Product/Process Change Notice (PCN)

20110808_PCN_StarTec_74271142_SMU.doc

Product Affected: 74271142 (S)

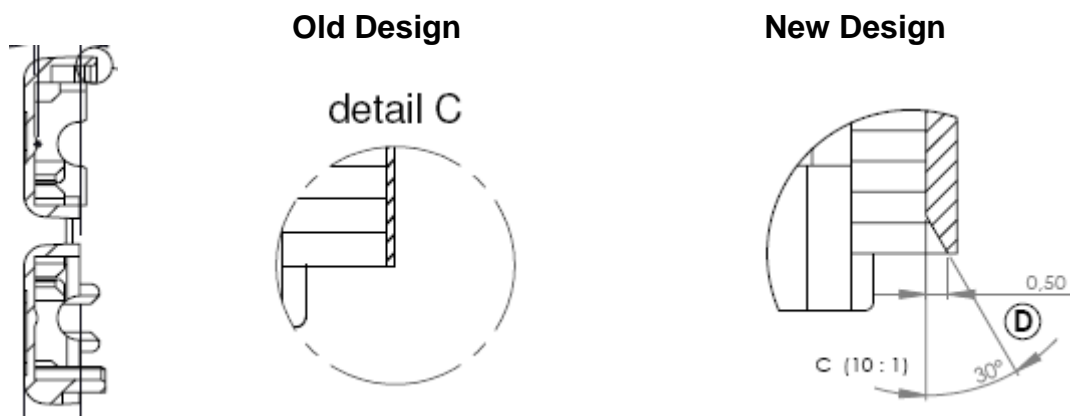
Based on *End of Life* of our current tooling of the snap ferrite 74271142 and 74271142S we have opened a new tooling.

The new tooling effects no electrical change of the part.

We add a fase for better closing of the snap ferrite:
